Service Kit

759-04145

Subject: Service Replacement for the 50" RZT Right Hand (RH) Hydro Transmission

FIGURE 1

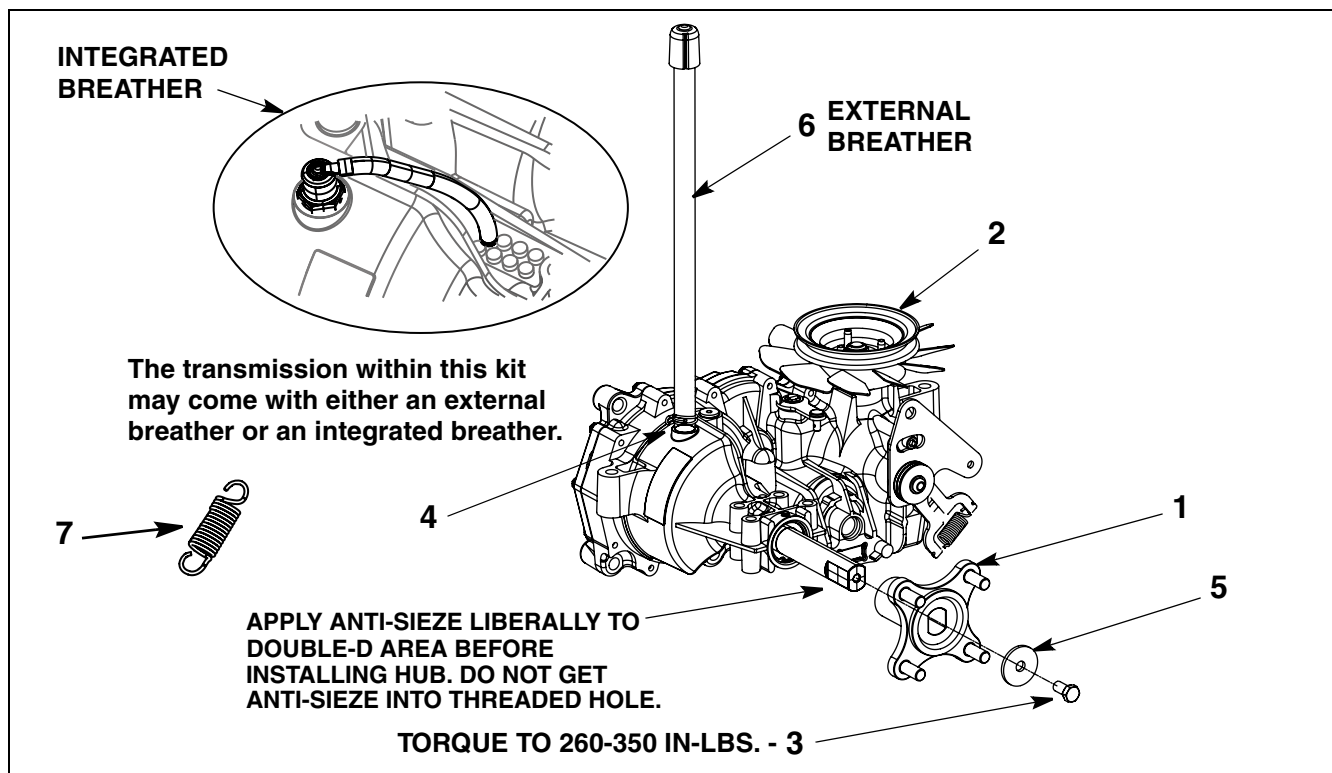
PURPOSE: This service kit replaces the RH hydro transmissions 618-04163A and 618-04326 which are no longer available. The replacement transmission has a Double-D axle end which requires a Double-D wheel hub assembly. A new neutral return spring is enclosed for the LH transmission. See instructions on page 2 of this sheet.

ITEM NO.	PART NUMBER	QTY	DESCRIPTION
1	618-04317	1	HUB ASM:WHL:DOUBLE-D LONG
2	618-04432A	1	TRANS ASM:HYDRO:EZT:RH
3	710-3119	1	SCREW:3/8"-16 x .750:GR5:LOCK
4	726-04059	1	CLAMP:HOSE: .750
5	736-0227	1	WASHER:FLAT: .390 x 1.50 x .134
6	751-10474	1	HOSE: BREATHER: EXTERNAL
7	732-04448	1	SPRING: EXTENSION (See Page 2)
8	*	1	THIS INSTRUCTION SHEET

FIGURE 2

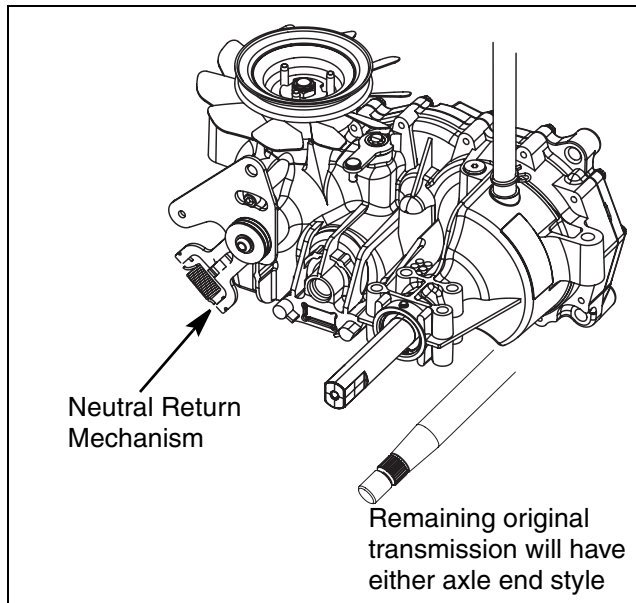
3. See Figure 2 for location of the neutral return mechanism.

FIGURE 3

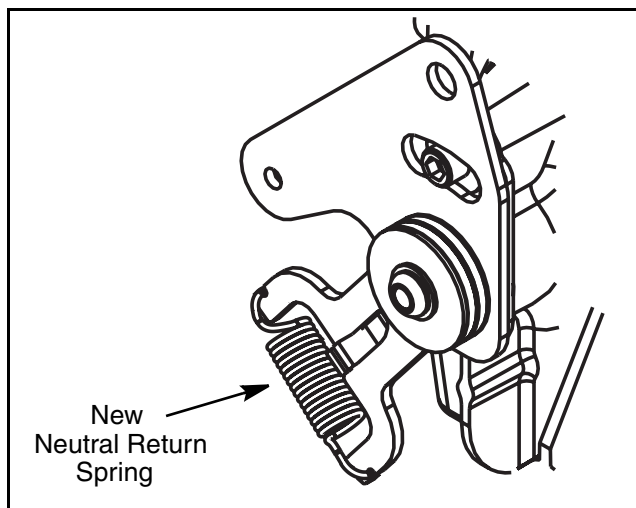
5. Install the new Neutral Return Spring, Item 7, onto the two arms as shown in Figure 3.

4. With a suitable set of pliers or spring removal tool, remove and discard the existing spring from the neutral return mechanisms two arms on the remaining (not replaced with this kit) hydrostatic transmission. See Figure 3.

6. When complete both installed transmissions must have the same color neutral return spring.
